**ADDISON AIRPORT  
BUILDING REPORT**

**Facility Information:** **Facility Name:** Cavanaugh Flight Museum - Hangar 3  
**Facility Contact:** Lisa Pyles **Contact Phone:** 972-450-2878

**Accessology Inspector Information:**  
**Inspector:** Karen Jackson **Date:** April 17, 2019  
**Email:** Kjackson@accessology.com

**Violation 3** - Restroom signage is mounted on the door.

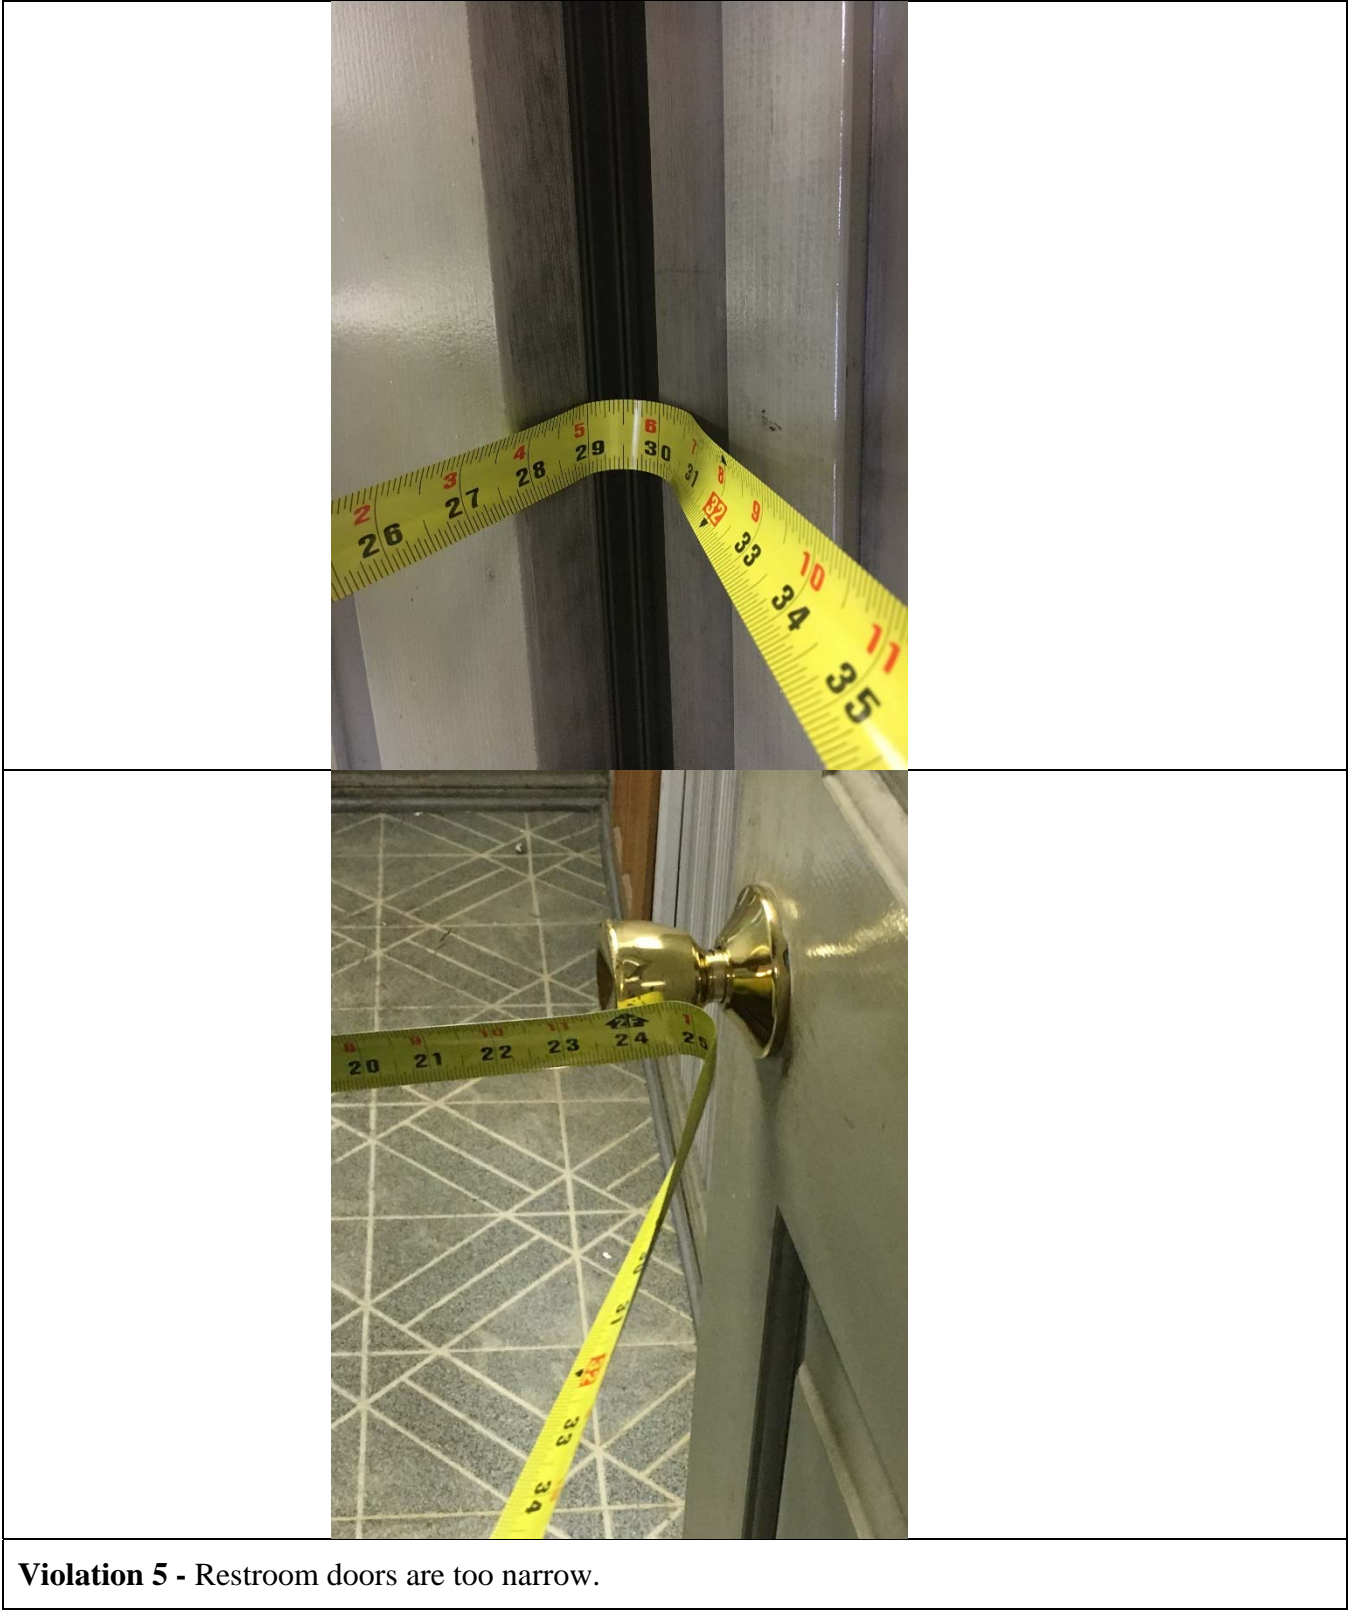
Restroom signage is mounted on the door.

2010 ADAAG 703.4.2 Location.

Where a tactile sign is provided at a door, the sign shall be located alongside the door at the latch side.

Install signage complying with Section 703.

**Violation 5** - Restroom doors are too narrow.

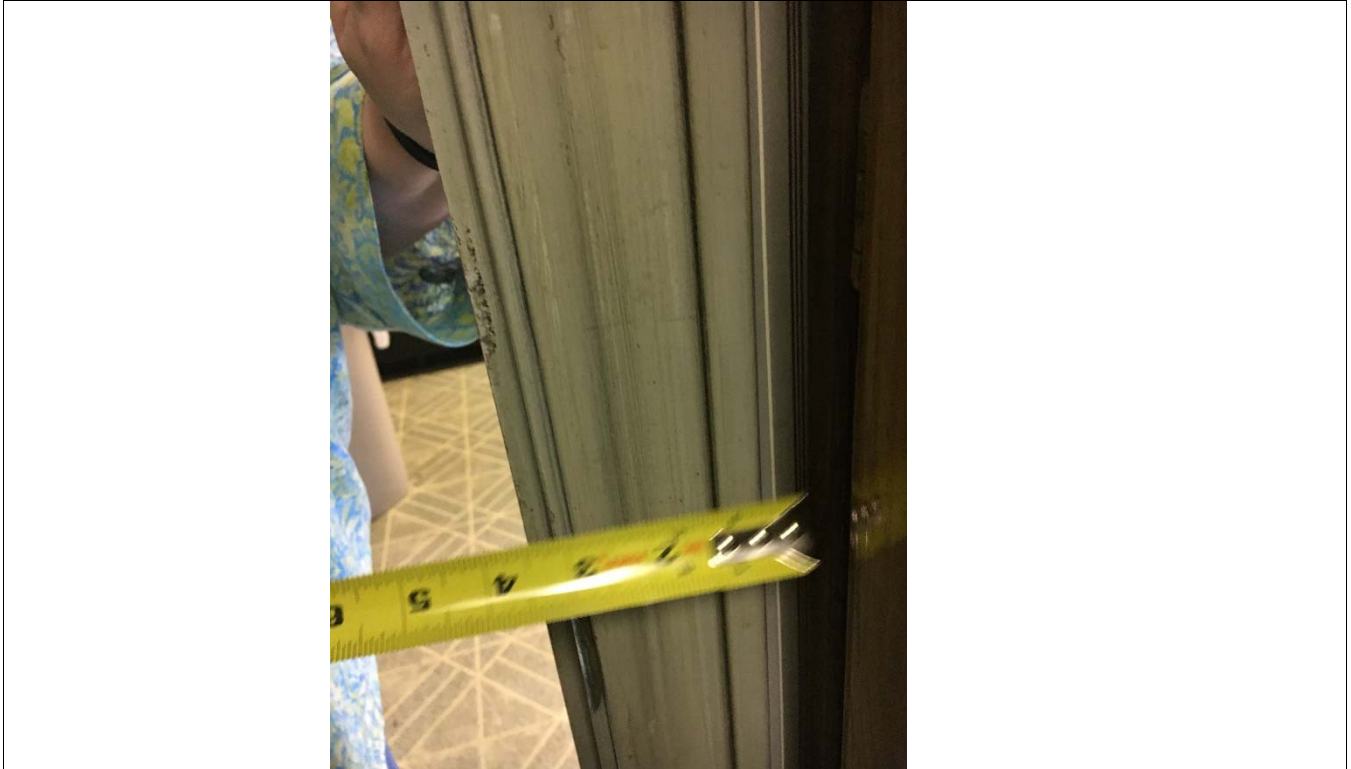
Restroom doors are too narrow.

Door openings shall provide a clear width of 32 inches minimum. Clear openings of doorways with swinging doors shall be measured between the face of the door and the stop, with the door open 90 degrees

**Violation 4** - Restroom doors have knob hardware requiring grasping and twisting to operate.

Replace doors to achieve 32" minimum clear width and swing doors outward.

**Violation 6** - Restrooms only have a 3-1/2" maneuvering clearance on the pull side where a minimum 18" is required.

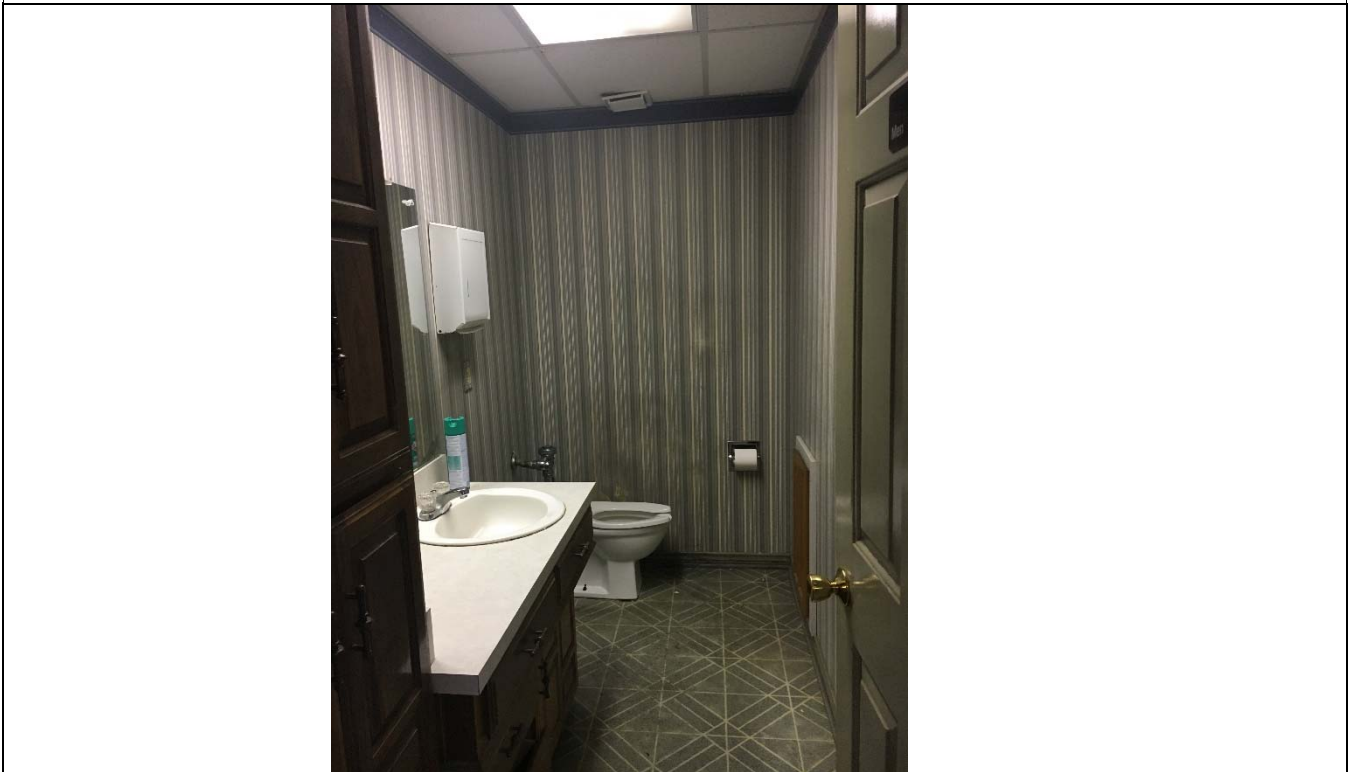
Restrooms only have a 3-1/2" maneuvering clearance on the pull side where a minimum 18" is required.

Swinging doors and gates shall have maneuvering clearances complying with Table 404.2.4.1.

Reverse the swing of the doors. Cost included under violation #5.

**Violation 7** - Restrooms are too narrow and are not large enough to accommodate a wheelchair turning space and could not be considered accessible restrooms.

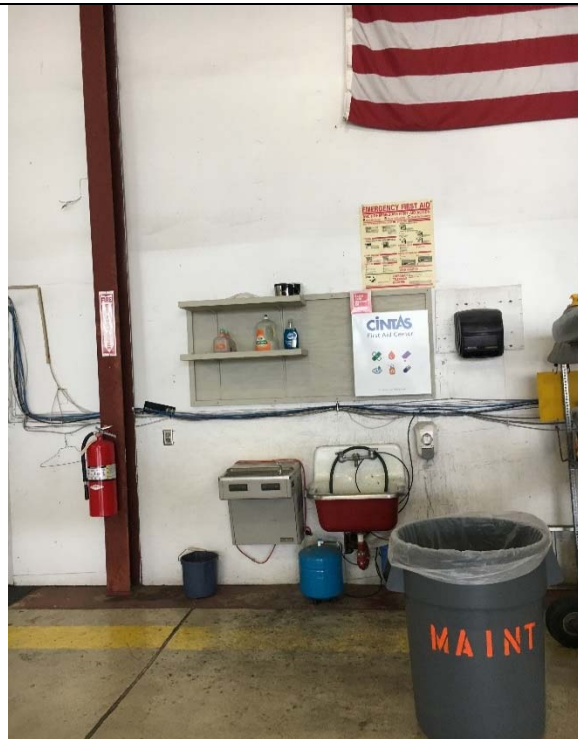
Restrooms are too narrow and are not large enough to accommodate a wheelchair turning space and could not be considered accessible restrooms.

Where toilet rooms are provided, each toilet room shall comply with 603.

Enlarge restroom to accommodate accessible water closet, lavatory and wheelchair turning space.
